INITIAL FIRE SAFETY INSPECTION REPORT

ECHOKNITS LTD (Extension)

RSC ID: 24842

Date: 27 December, 2023

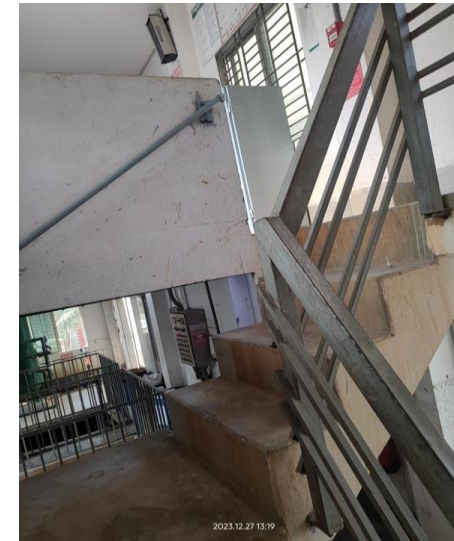
SI No.	Category	Findings	Required Action	Remediation Time Frame
F-1	Fire rated Construction	The shed-13 is a new building which height is more than 11m. Main structural element of the building is constructed by steel which is non-rated and were found in exposed condition without any fire protection.	The building is a new steel structure which shall meet fire rating requirement imposed on BNBC-2020. Provide require fire rating in the structural elements of the building as per BNBC 2020 Part 3 Table 3.1.7 & Table 3.3.1 (a). Consult with a qualified fire protection engineer. Submit the proposed drawing/design to RSC for review. Once reviewed, install passive fire protection as per reviewed design.	Within 6 months
